UT to Town Creek Restoration Project – Option A Year 3 Monitoring Report

Subject: Task 9: Annual Final Monitoring Report – Monitoring Year 3 & Response to Comments
UT to Town Creek Restoration Project – Option A
Yadkin River Basin – CU# 03040105 – Stanly County, NC
NCDMS Project ID No. 94648; NCDEQ Contract No. 003277

Please find enclosed the Final Year 3 Monitoring Report and our responses to the Division of Mitigation Services (DMS) review comments received on December 14, 2018 regarding the UT to Town Creek Restoration Project – Option A, located in Stanly County, NC. In response to the referenced review comments, we have revised the Final Year 3 Monitoring Document, as needed. Each response has been grouped with its corresponding comment and is outlined below.

NC Center for Geographic Information & Analysis

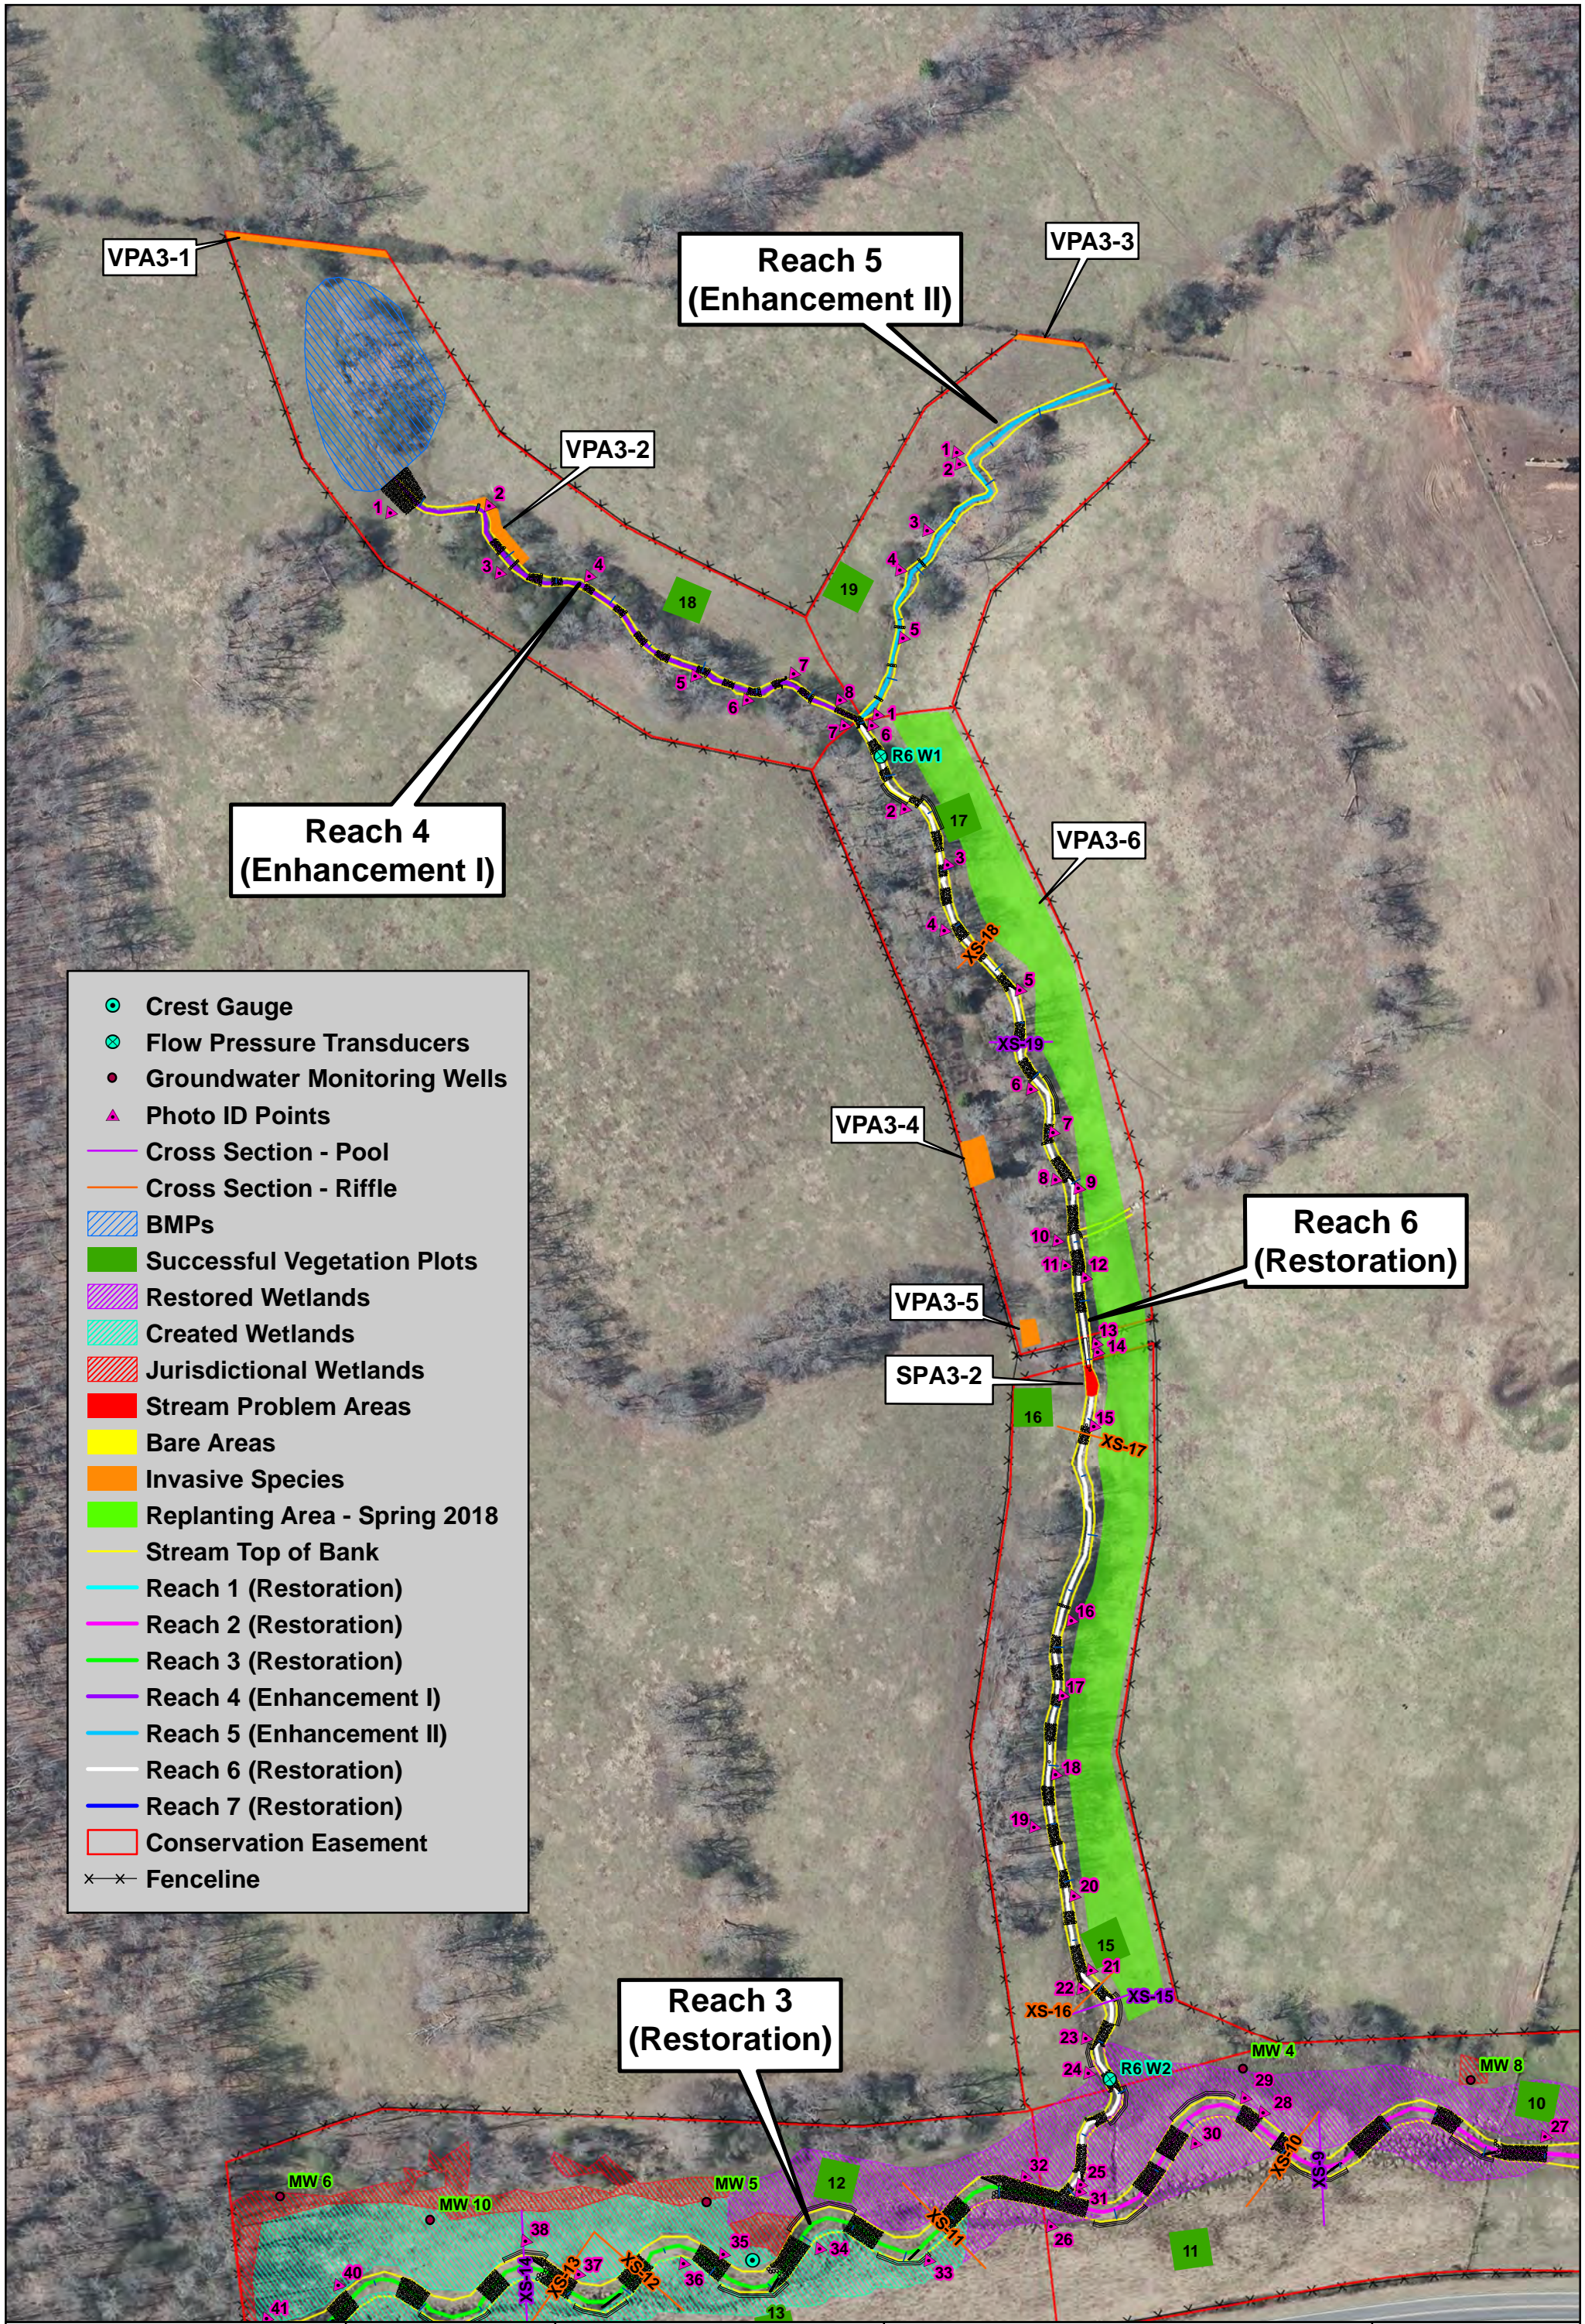
Table 6a – Invasive Areas of Concern indicates 0 polygons and 0.00 combined acreage. Even if individual “polygons” are below the 1000 SF threshold, the acreage of invasives as a concern should not be zero, based on my field assessment. Please provide an accurate estimate of acreage needing treatment for this table, as the existing numbers indicate the site is invasive-free which is not the case. Similarly, Bare Areas and Areas of Poor Growth or Vigor (e.g., Reach 3) should be cataloged accordingly.

Response – Table 6a and Table 6b have been revised to include vegetative problem areas (VPAs) throughout the project area. Figures 2 through 2c have been updated to reflect VPA locations. The MY3 report text has been updated to reflect VPA corrections.
